VISUAL INSPECTION

A-17

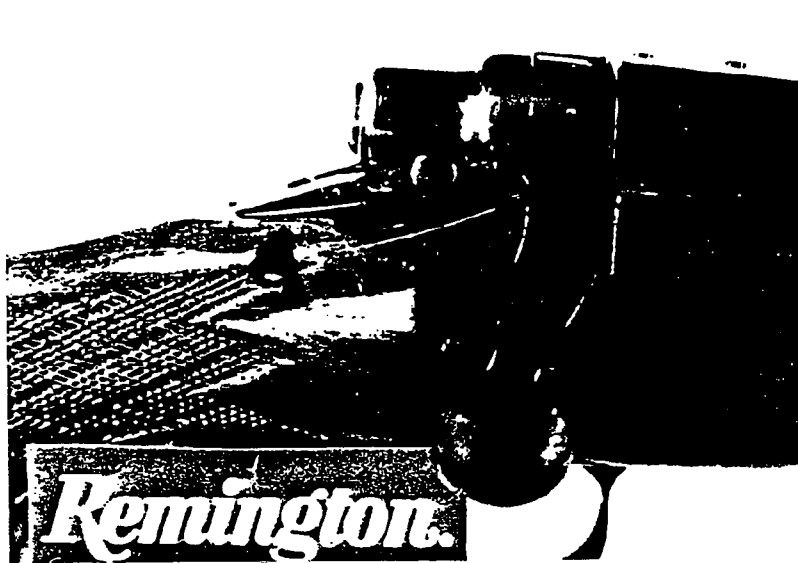
Rear tang not
flush with the
stock.

Stock rein-
forcement pins
are egg shaped
